Proposal for Supplement 3 to the 03 Series of Amendments UN Regulation No. 100 (Electric power-train vehicles)

Submitted by the experts from the International Association of the Body and Trailer Building Industry (CLCCR)

Figure 3
Marking of vehicles of category O: Use of wheel chocks

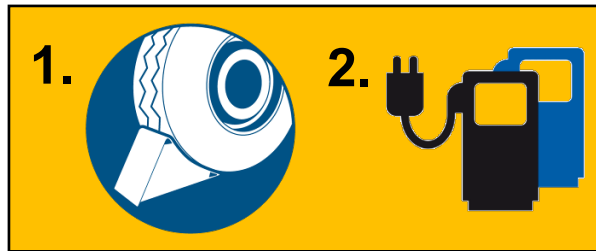
"5.3.3. If the REESS can be externally charged, vehicle movement by its own propulsion system shall be impossible as long as the vehicle connector is physically connected to the vehicle inlet.

In case of vehicles of category O the vehicle shall provide an audible warning if a vehicle movement is detected.

In cases the trailer REESS is charged externally the trailer shall provide an audible warning if a trailer movement is detected. Furthermore a instruction to use wheel chocks is to be placed on a label near the trailer inlet.

Figure 1
Generic description of test pulses

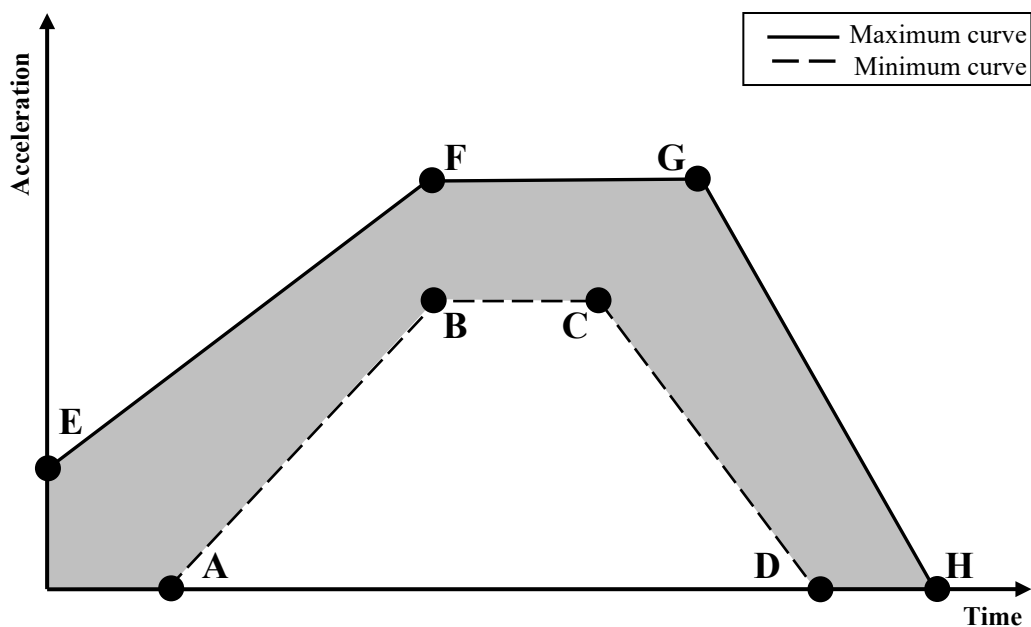
The Tested-Device shall be decelerated or accelerated in compliance with the acceleration corridors which are specified in Tables 1 to 3. The manufacturer shall decide whether the tests shall be conducted in either the positive or negative direction or both.

The test pulse shall be within the minimum and maximum value as specified in Tables 1 to 3. A higher shock level and /or longer duration as described in the maximum value in Tables 1 to 3 can be applied to the Tested-Device if recommended by the manufacturer.

The resistance against mechanical shock are focusing on pulses of crash tests or similar performance tests of vehicles of category N1, N2, N3, M1, M2 and M3. Trailers are normally not in the scope of crash test regulations due to missing passengers. Therefore it is recommended to define basic performance pulses for trailers in relation to the category of the trailer. REESS on O1/O2 may be tested with the pulse as defined for N3. REESS for O3/O4 may be tested with a pulse related to requirements from the ADR („Accord européen relatif au transport international des marchandises Dangereuses par Route" – Transport of dangerous goods).

Table 3 for M₃, and N₃, O₃, O₄ vehicles:

Point	Time (ms)	Acceleration (g)	
		Longitudinal	Transverse
A	20	0	0
B	50	6,6	5
C	65	6,6	5
D	100	0	0
E	0	4	2.5
F	50	12	10
G	80	12	10
H	120	0	0
